Access Compliance Report

Public Rights-of-Way

(Curb Ramps)

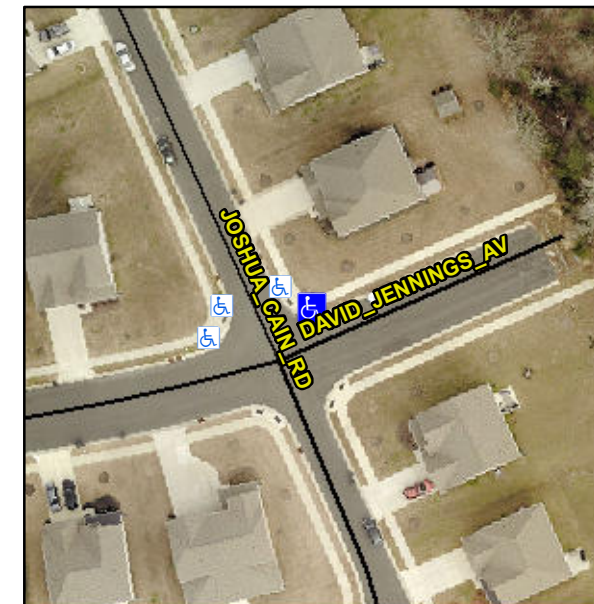
Not Found, R304.5.1

Compliance	Description	Data	Compliance	Description	Data
N/A	Ramp Length (in)	53.0	Yes	Ramp Slope (%)	6.4
No	Ramp Width (in)	47.0	Yes	Ramp XSlope (%)	1.4
N/A	Flare Type LT	N/A	N/A	Flare Type RT	N/A
N/A	Flare Slope LT (%)	N/A	N/A	Flare Slope RT (%)	N/A
N/A	Flare Traversable LT?	N/A	N/A	Flare Traversable RT?	N/A
N/A	Landing Length (in)	N/A	N/A	DWS Provided?	N/A
N/A	Landing Width (in)	N/A	N/A	DWS Contrast?	N/A
N/A	Landing Slope (%)	N/A	N/A	DWS Length (in)	N/A
N/A	Landing X Slope (%)	N/A	N/A	DWS Full Width?	N/A
N/A	Landing Curb? (Y/N)	N/A	N/A	DWS Offset (in)	N/A
N/A	Shared Landing?	N/A			
N/A	Gutter Ponding?	N/A	N/A	Gutter Slope (%)	N/A
N/A	Gutter Lip Ht (in)	1.0	N/A	Gutter X Slope (%)	N/A
N/A	Painted X Walk1?	No	N/A	Painted X Walk2?	N/A
	X Walk 1 Direction	To S		X Walk 2 Direction	N/A
N/A	X Walk 1 Width (in)	N/A	N/A	X Walk 2 Width (in)	N/A
	X Walk 1 Slope (%)	3.0		X Walk 2 Slope (%)	N/A
	X Walk 1 X Slope (%)	2.2		X Walk 2 X Slope (%)	N/A

Remove & Replace Entire Ramp.
